Vermont Agency of Transportation
RECEIVED
 CK'D BY JG OK'D BY JS
 May 1, 2014
 RESUBMIT YES Rejected
 BY KH DATE 5-8-2014

J.P. CARRARA & SONS INC. Precast & Prestress Manufacturer <small>244 GEE ST., WOODBURY, VERMONT 05753 Phone:(802)388-6361 Fax:(802)388-9010</small>		COLD RIVER BRIDGES, LLC CONTRACTOR <small>WALPOLE, NEW HAMPSHIRE</small>	
STATE OF VERMONT AGENCY OF TRANSPORTATION COUNTY OF RUTLAND		DATE: FEB. 3, 2014 SCALE: NOTED	
TOWN OF PITTSFIELD VT ROUTE 100, (MINOR ARTERIAL) BRIDGE NO.: 124 PROJECT NO.: ER BR 022-1 (23)		CHKD: - DFTM: T.D. JOB NO: 23416-015	
COVER SHEET		DWG. NO: C1

TOWN OF PITTSFIELD
 VT ROUTE 100, (MINOR ARTERIAL)
 BRIDGE NO.: 124 PROJECT NO.: ER BR F 022-1 (23)

3 BEARING SECTION
F2 NEXT BEAM STEM BEARING 3/4" = 1'-0"

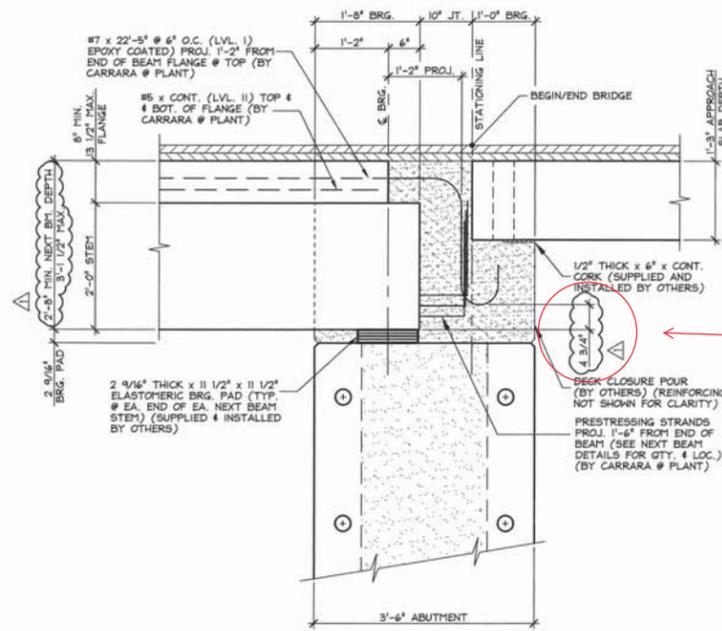
Bottom of hook should extend to bottom of beam. Bar length is correct on sheet 16. Bar projection distance is 3'-5". The dimension needs to be revised throughout the plan set.

2 END BLOCK STEM REINFORCING DETAILS
 NB4A 3/4" = 1'-0"

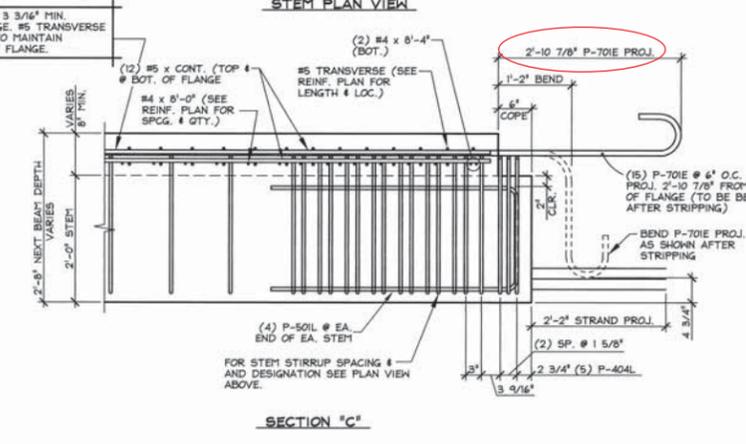
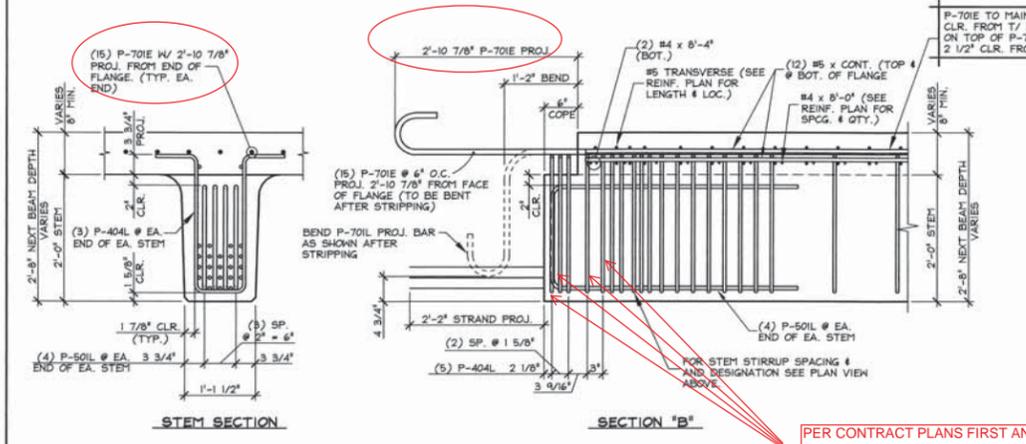
PER CONTRACT PLANS FIRST AND THIRD PAIRS WILL BE BUNDLED (TYP)
